**Agenda item:** AdHoc #24 HSDPA  
**Source:** Motorola  
**Title:** Comments on Lucent's Proposal on HSDPA  
**Document for:** Discussion

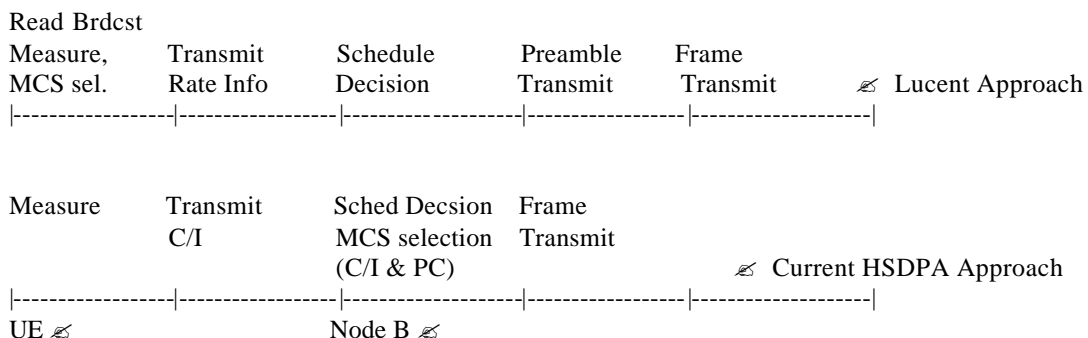
- ?? A low cost terminal controls an expensive set of Node Bs. Although, the Node B may not schedule a user if it is unable to provide the data rate demanded by the user, this philosophy of assigning rates to the HS-DSCH by the UE is unlikely to be popular with the operators since they do not want to relinquish the control of their infrastructure to a low cost UE.

- ?? The UE has to continuously monitor all the broadcast channels transmitted from multiple cells. This will require additional despreading resources at the UE.

- ?? Assigning an additional common control channel, will increase the overhead at the Node B. Further, in multi-coverage regions where the geometry is quite low, the amount of power required for reliable reception of the common broadcast channel will be prohibitive.

- ?? A simpler alternative for picking the best Node B is to measure the pilot  $E_c/I_o$  at the UE and use absolute pilot strength information. This information allows the UE to correctly choose the Node B with the best transmission gain. As currently defined in 25.331, the UE would get the pilot strength of each entry in the monitored set via the measurement command message (MCM). The Node B physical resource limited case can be handled by managing the UEs active set. Typically, this management would only need to be done for stationary users.
